## CDR Phase 3

**SEP 020 Headworks Project**

**November 27, 2018**

# Design Revisions

Based on CDR Phase 2 Comments

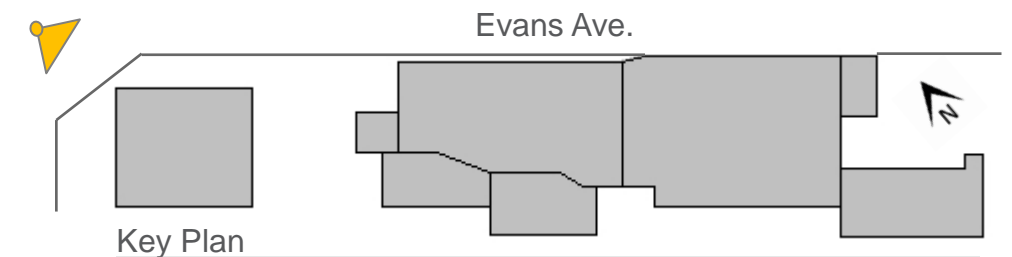
### CDR Phase 2 comments

- Grit Handling zinc cladding
- Art Wall-to-Architecture transitions

## Grit Handling Zinc & Stair Screening

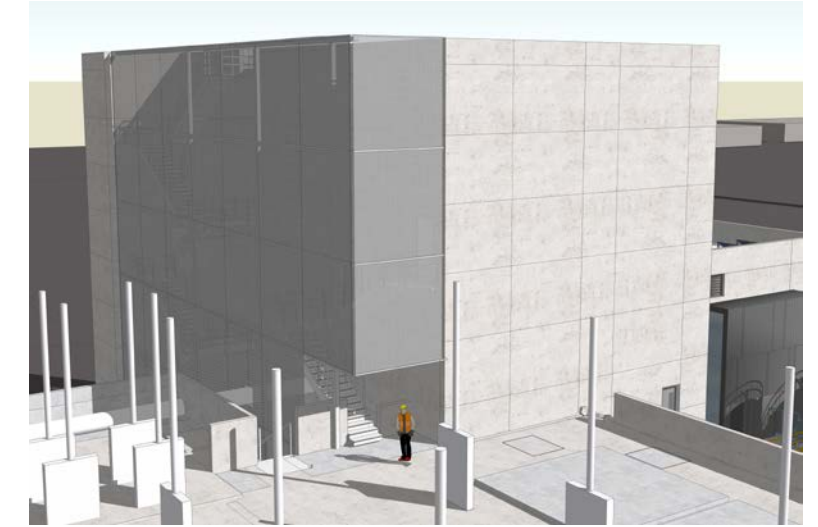
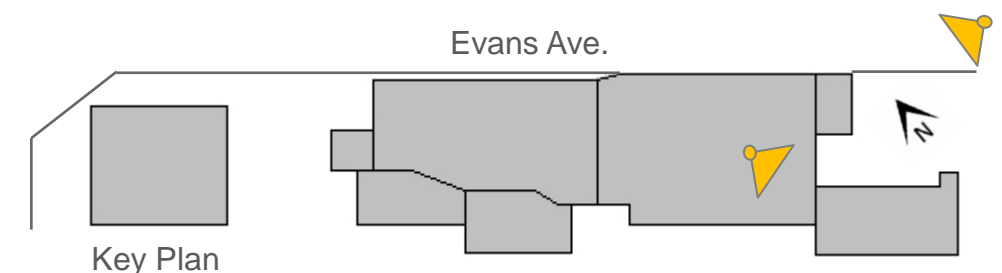
### CDR Phase 2 comments

- Improve zinc expression
- Continue to simplify design
- Unified stair screening a good design move

### Revised Design Comments

- Zinc cladding developed as a SEP campus design element to emphasize and call out vertical circulation

## Art Wall Transition to Grit Tank

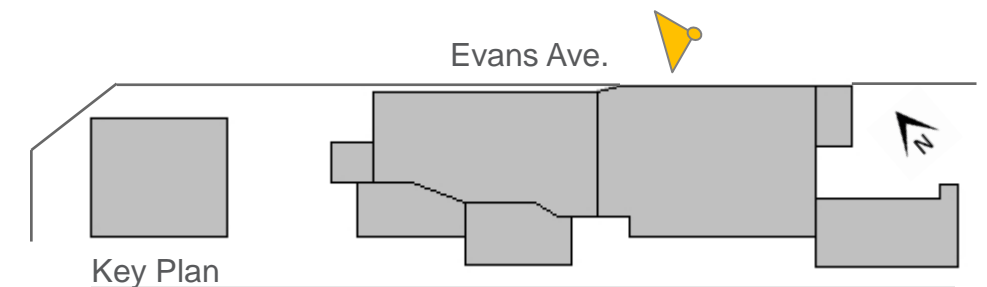
### CDR Phase 2 comments

- Resolve transition between art wall and architecture
- Express the connection between art and concrete

### Revised Design Comments

- Art wall required to be on property line due to new pipes and equipment in space behind
- Art wall reads as a separate volume
- 18" wide reveal between art wall and grit tank concrete
- ~24" deep return to Grit Tank with metal panel by artist

## Art Wall Transition to Truck Gate

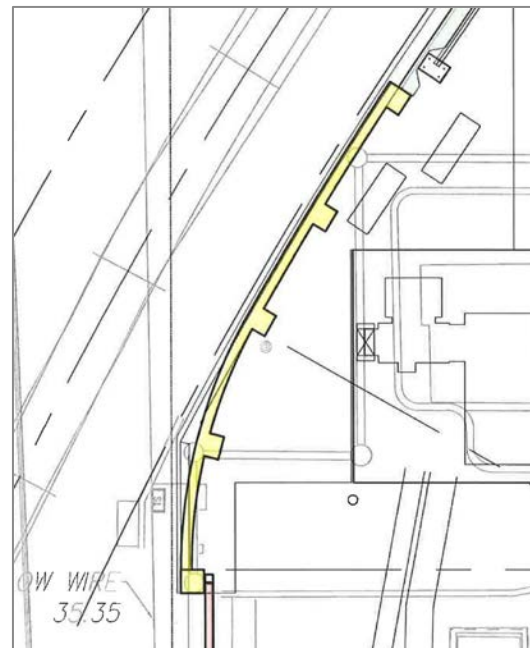
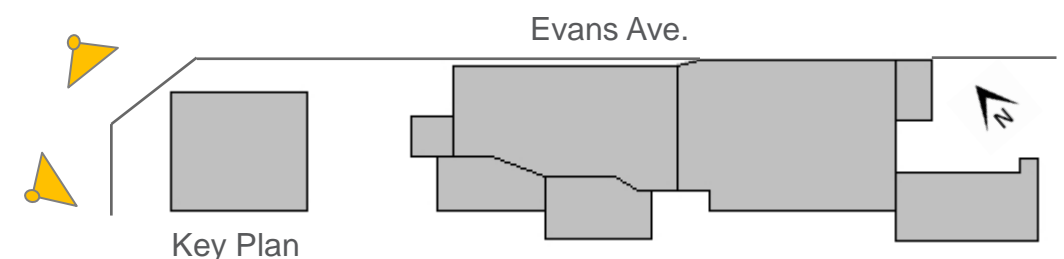
### CDR Phase 2 comments

- Resolve transition between art wall and architecture
- Express the connection between art and concrete
- Curve the wall at truck gate

### Revised Design Comments

- Art wall reads as a separate volume
- 18" wide reveal between art wall and concrete wall
- Art wall set in ~10" to make room for fins along train line
- 30' H curved concrete wall creates 'frame' similar to Grit Tank
